Planning Application Ref: CM/0022/22

Land to the Southeast of Hornage Farm, Bicester Road, Chilton, HP18 9SE
Erection of Anaerobic Digestion Facility, Comprising Silage Clamps, Digester Tanks,
Lagoons, Administrative Buildings, Ancillary Development Including Gas Grid
Connection, Landscaping and Access

OBJECTS

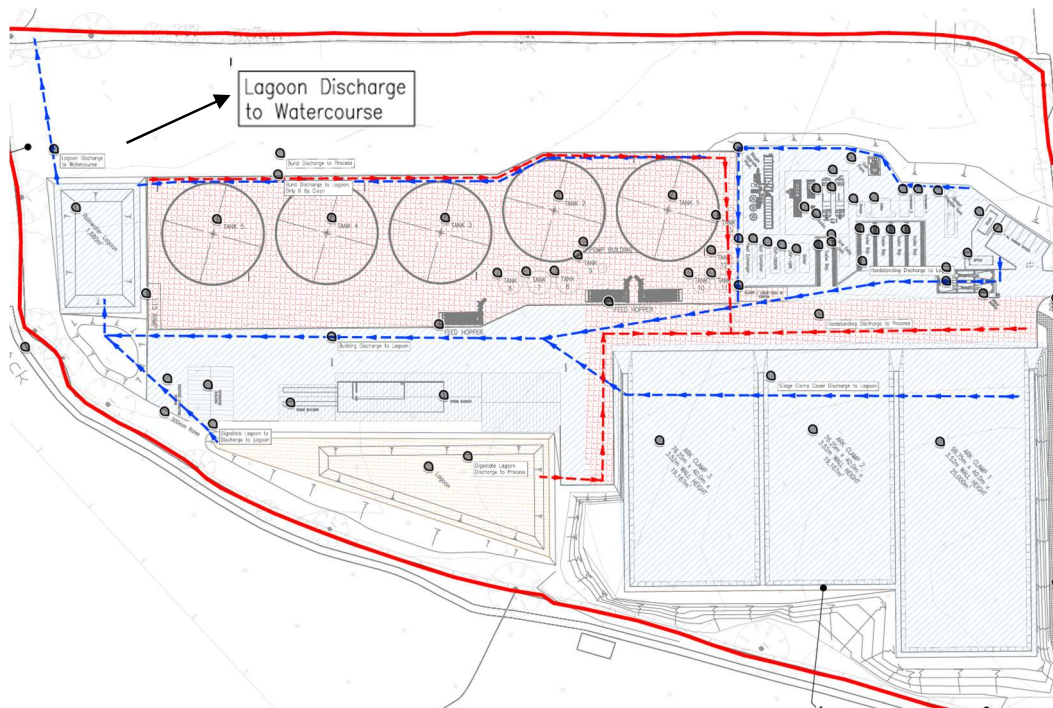
- 2.5 **Impact of Reduced Digestate Lagoon on Hornage Brook.** The Applicant's Amended Proposed System Catchment Plan clearly shows that excess liquid from the storage clamps and digestate lagoon will flow to the rainwater lagoon (1680 M3). Any excess from the rainwater lagoon will be discharged into Hornage Brook, which is in Flood Risk Zone 3. The risk of overflow from the Digestate Lagoon is

presumably increased due to the 55% reduction in capacity from prior plans. As mentioned above, the capacity of the storage clamps, based on Acorn's own measurements is potentially 44% below prior plans. Taken together, we have to assume that **the likelihood of digestate/pollutants being discharged into Hornage Brook (Flood Risk Zone 3) has actually been increased** by Acorn's decision to move the plant 40 Metres to the south and out of Flood Risk Zone 3

2.11 Impact of sewage treatment facility at Kirtland Farm, (51.77778, -1.061484).

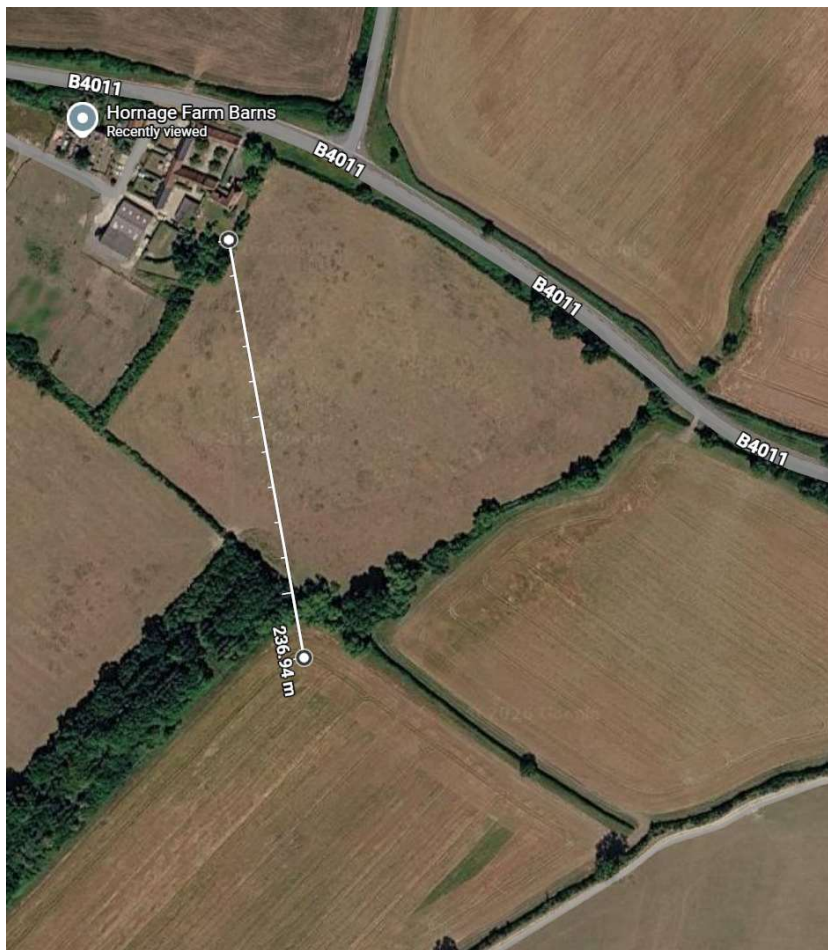
Acorn should assess and all relevant consultees should comment on the cumulative impact of the existing sewage treatment facility at Kirtland Farm, alongside the application proposals, on air quality and heritage assets in the EIA. The cumulative impact of emissions from this facility and the proposed anaerobic digester should be included in the applicant's Air Quality Assessment and reviewed by Natural England and the Environment Agency before any planning decisions are made. Currently, none of the Air Quality Assessments provided by Acorn or conducted on behalf of the LPA recognise the impact of an existing waste treatment facility about 2.9 KM southwest of Hornage Copse on background emissions.
